ADDENDUM 1

ADDENDUM DATE: November 05, 2024

PROJECT: Onslow County Senior Services Center Renovation
4024 Richlands Highway
Jacksonville, NC 28540

7 TRAINING ACTIVITY - OPERABLE PARTITION DETAIL
1 1/2" = 1'-0"

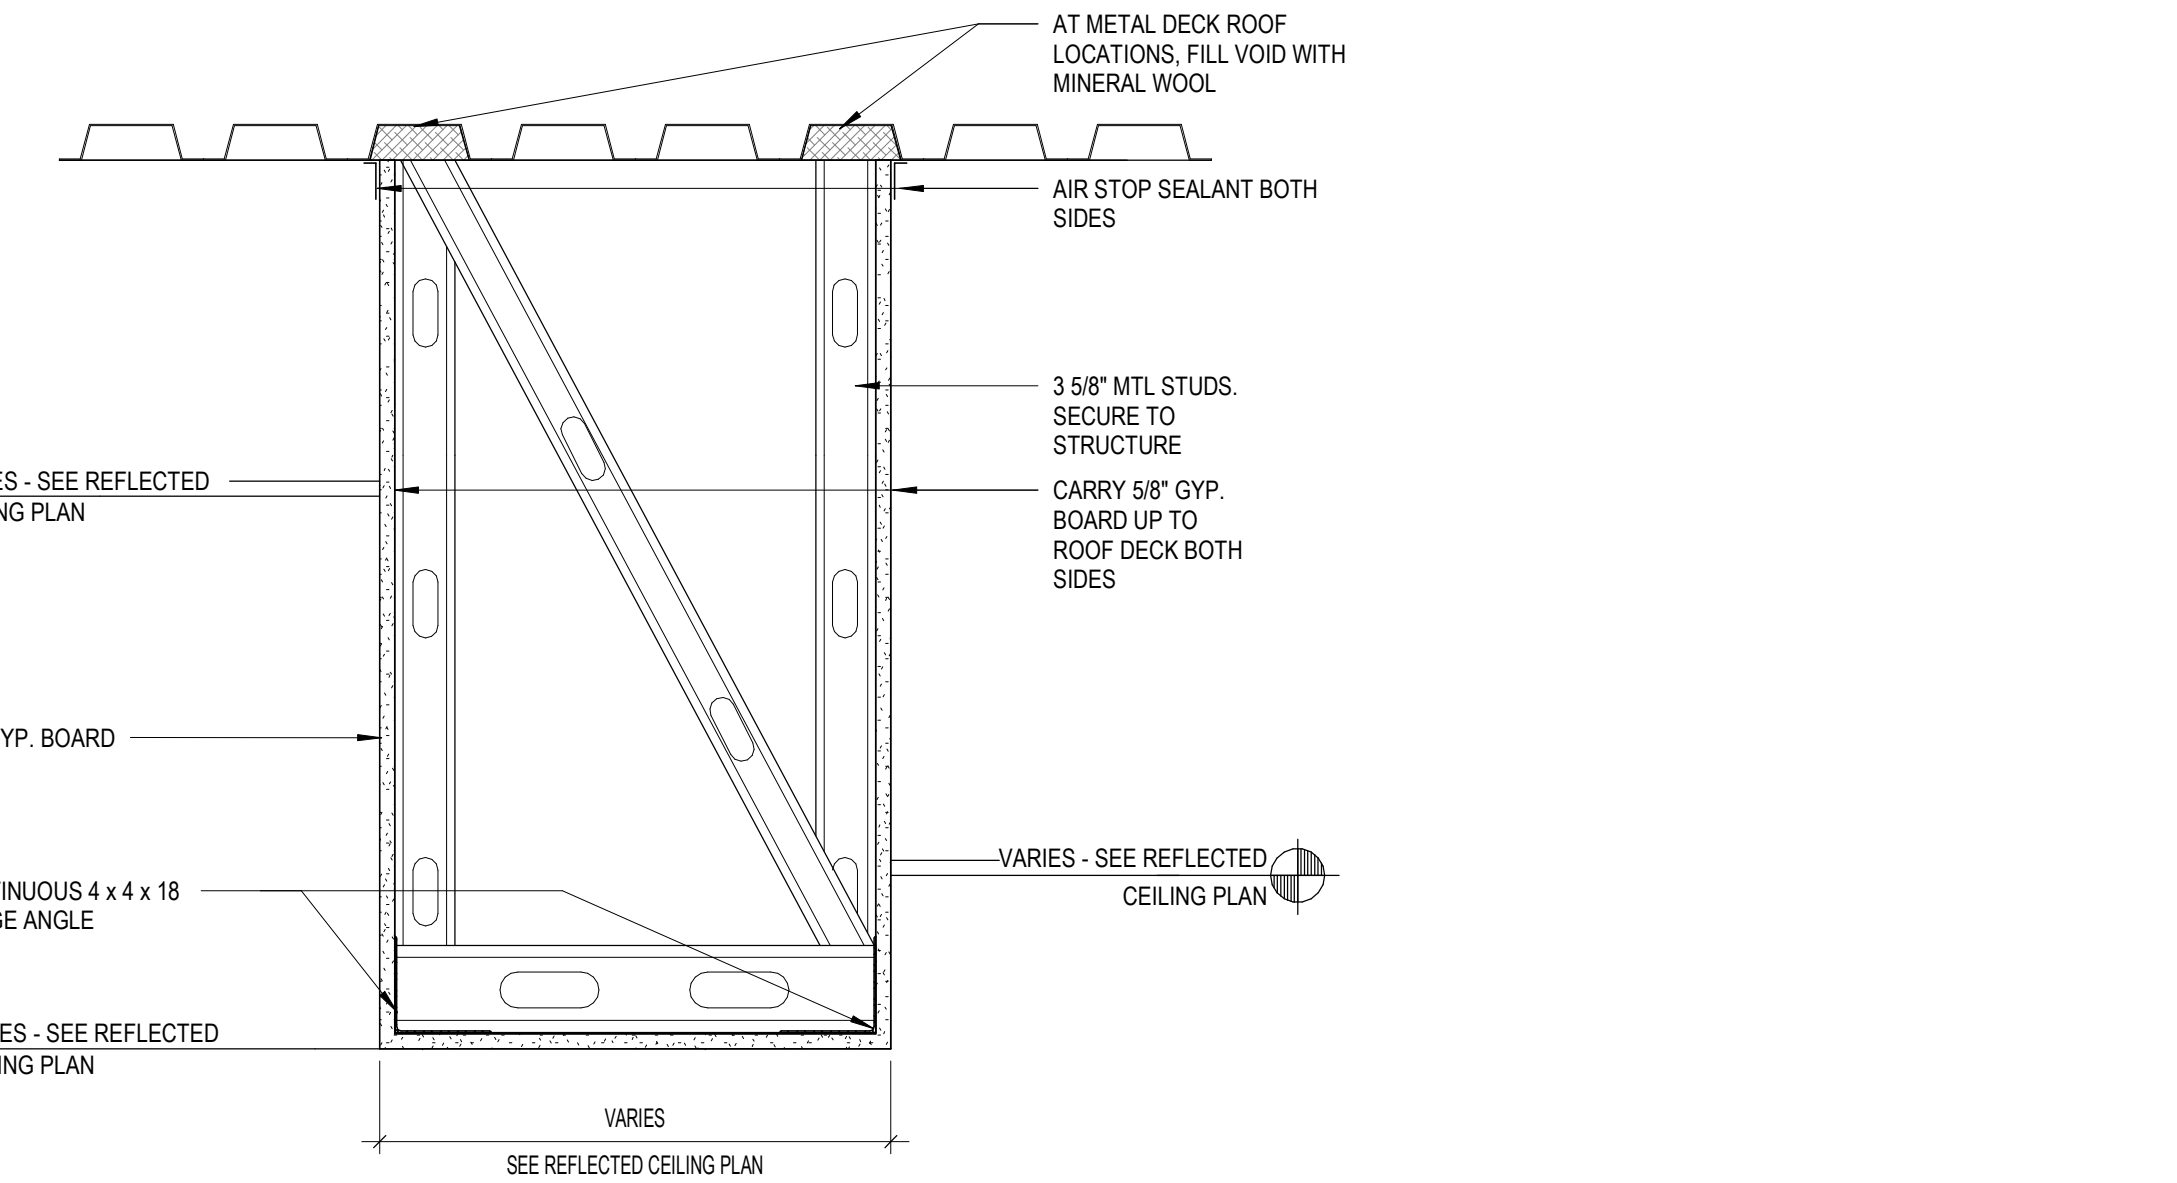
- 7/A5-03 - Addition of 3 5/8" metal studs at 32" O.C. added to bulkhead.
 - 7/A5-03 and 15/A5-03 - Addition of 4"x4" continuous cold formed angle at corners of bulkhead.

WINDOW LEGEND
1/4" = 1'-0"

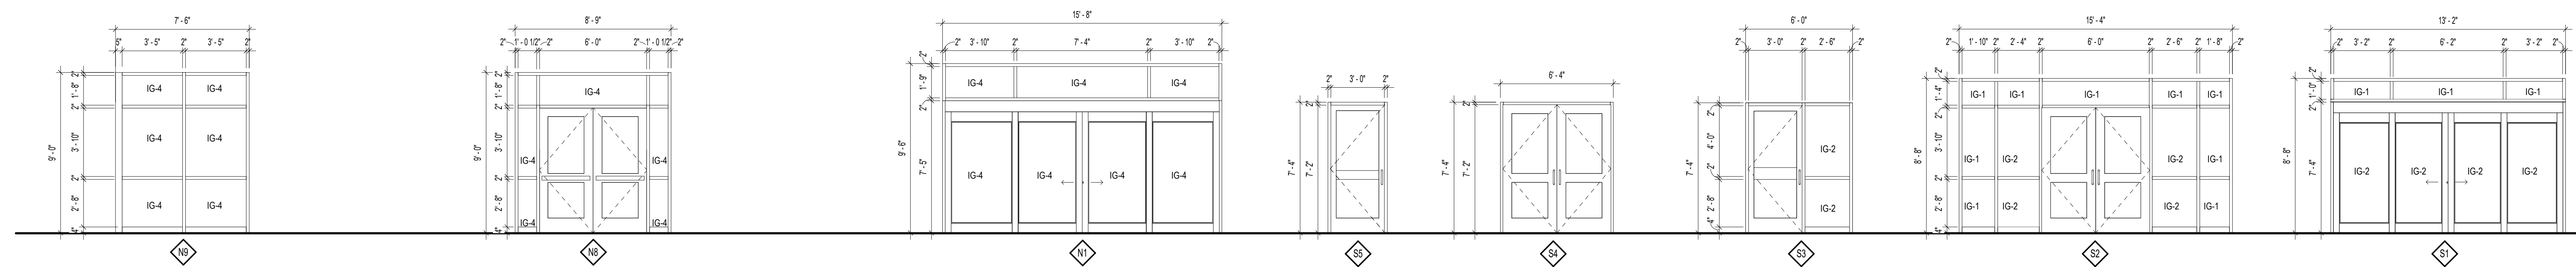
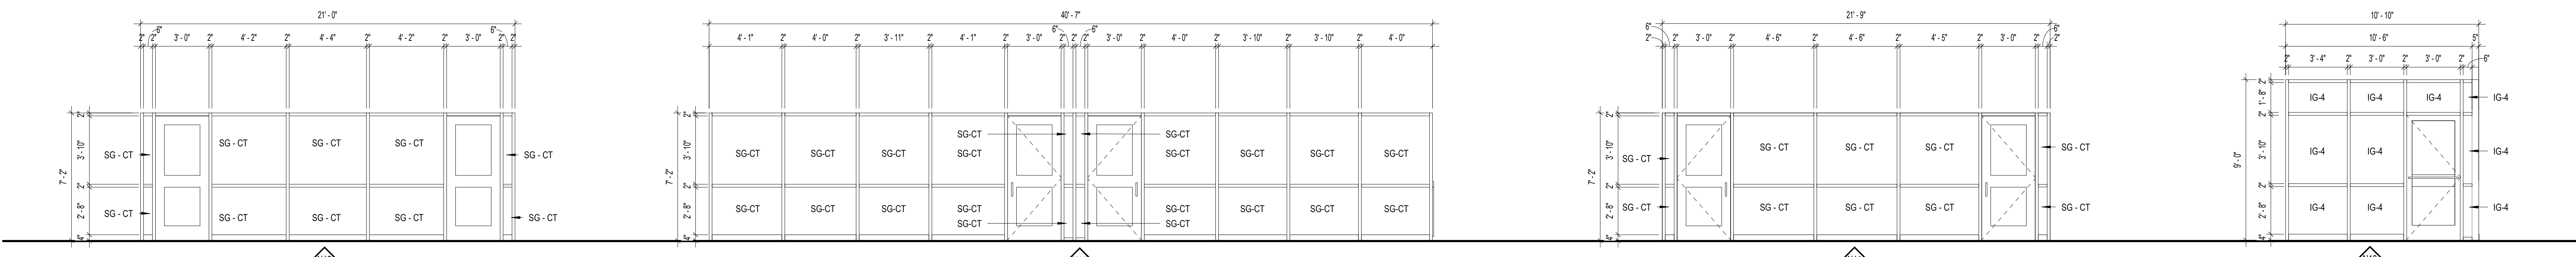
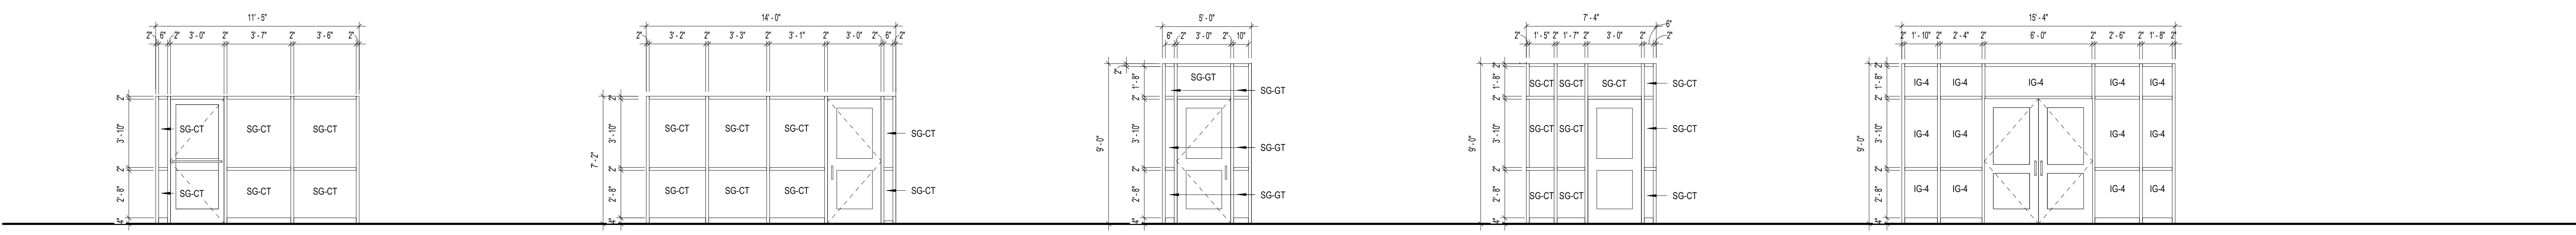
- Revision to top of CS1 sill height to be set at 2'-10".
 - Revision to AL1, AL2-A, AL5, AL6-A and AL7-A head details.
- Item 28 Sheet A9-07: REPLACE the sheet in its entirety with the attached sheet A9-07.
Note the following revisions:

ADDENDUM 1
REVISION
1. DIMENSION 2'-10" CHANGED TO TOP OF CS1 SILL

1 WASTE AND VENT RISER DIAGRAM
NOT TO SCALE

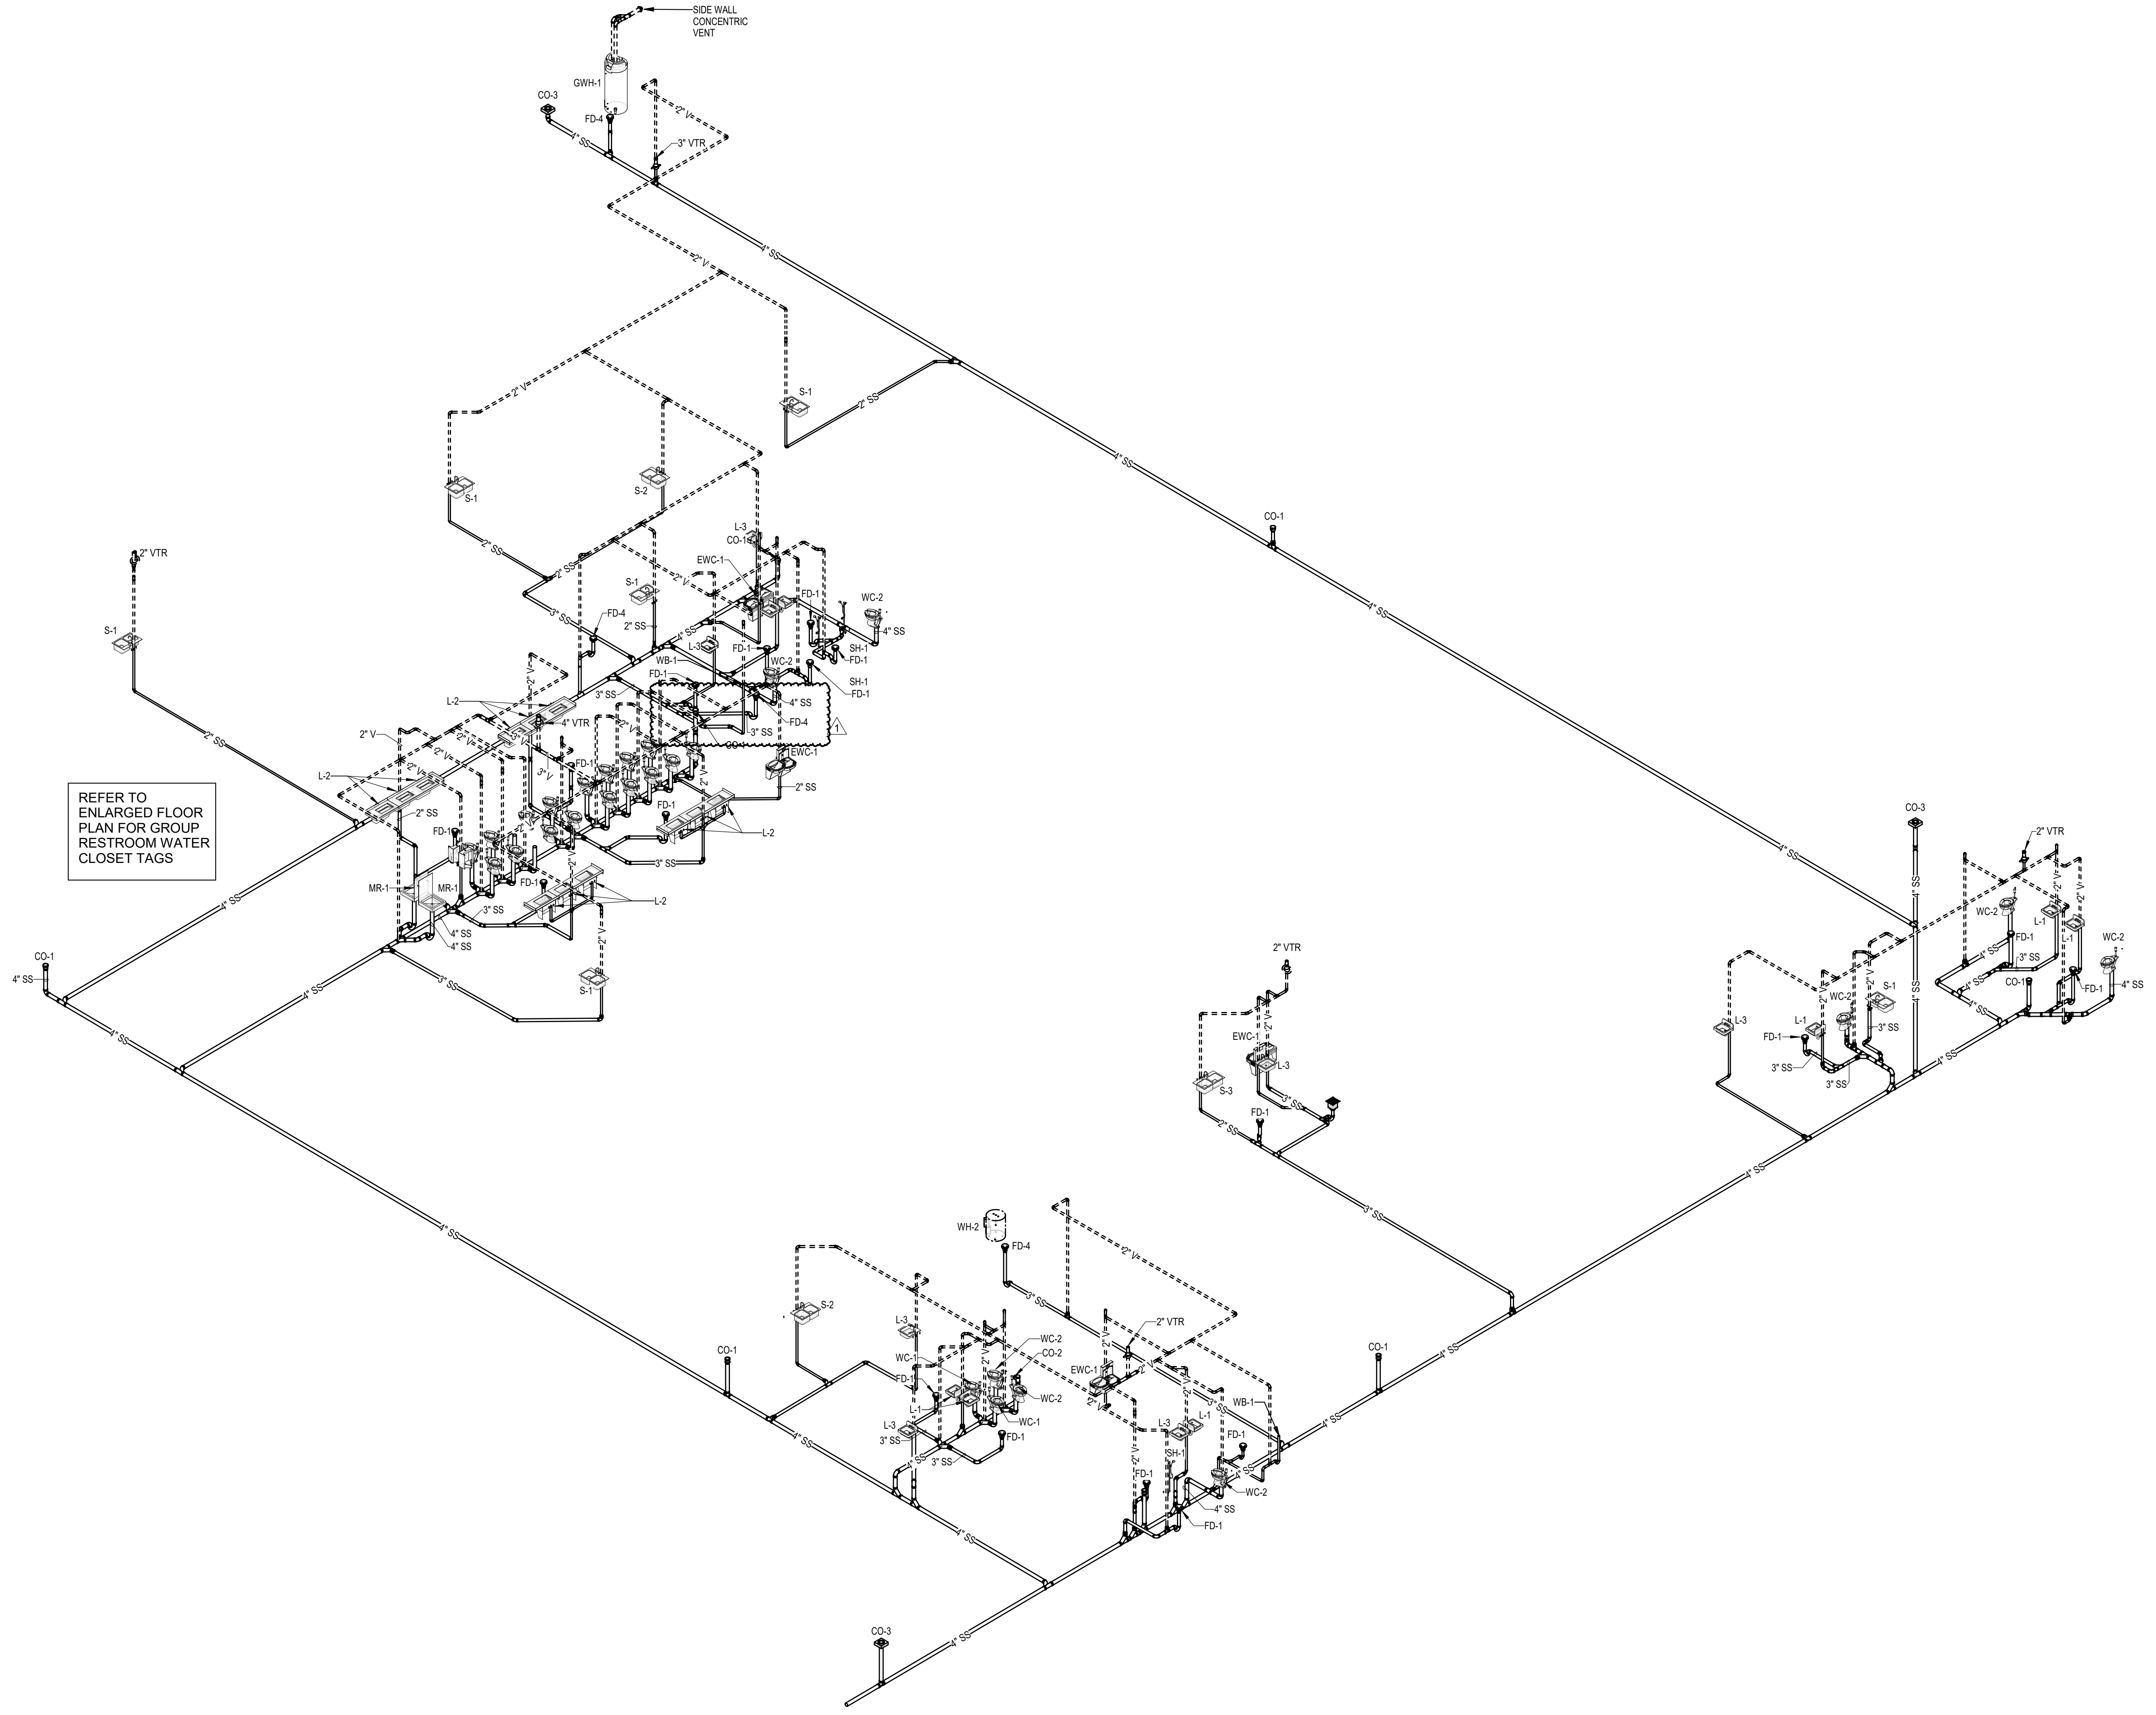
- Item 30 Sheet P2-01: REPLACE the sheet in its entirety with the attached sheet P2-01.
Note the following revisions:
- Added: FD-4 Hub Drain to Laundry 244 for condensate from DS-3 on mechanical sheet M2-02.
- Item 31 Sheet P2-02: REPLACE the sheet in its entirety with the attached sheet P2-02.
Note the following revisions:
- Added: FD-4 Hub Drain to Laundry 244 for condensate from DS-3 on mechanical sheet M2-02.
- Item 32 Sheet P4-01: REPLACE the sheet in its entirety with the attached sheet P4-01.
Note the following revisions:
- Revised waste and vent riser for added hub drain.

1. Drawing P2-02
 - a. Added: FD-4 Hub Drain to Laundry 244 for condensate from DS-3 on mechanical sheet M2-02 .
2. Drawing P4-01
 - a. Revised waste and vent riser for added hub drain.
